File Number: 12-E-25-IH

**Meeting:** 12/17/2025  
**Applicant:** Logan Higgins Heyoh Design & Development  
**Owner:** Quinn Epperly QB Realty Team LLC  
**District:** Edgewood Park Infill Housing Overlay District

**Location:** 2802 N. Broadway **Parcel ID:** 81 D E 001  
**Zoning:** C-G-2 (General Commercial)  
**Description:** New primary structures

Staff recommends postponement of Certificate 12-E-25-IH to allow the applicant to resolve zoning issues, clarify details on the site plan, and provide unique elevation drawings.

PROPOSED ZONING DIAGRAM (1" = 50')

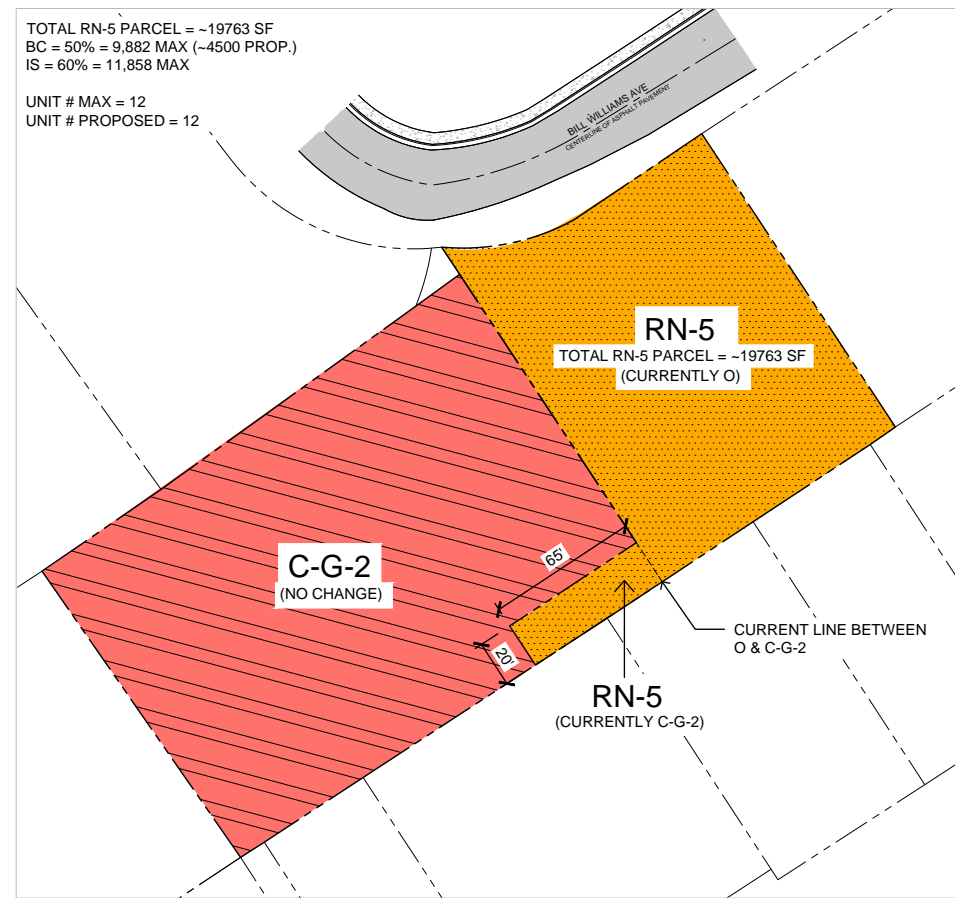
1. The plans indicate a third apartment building on the neighboring parcel (081DE005) that is labelled "phase II" and is not part of this application because a 12-unit apartment building is not currently a permitted use. The applicant is

requesting to rezone parcel 081DE005 and a 65' wide by 20' deep section at the southeast corner of 2802 N Broadway to the RN-5 (General Residential Neighborhood) zone (map at end of file), and the case (1-I-26-RZ/1-B-25-SP/1-C-25-PA) will be heard at the January 8 Planning Commission meeting. Both depicted parking lots are included in this application, but the third building will need to be reviewed with a separate application.
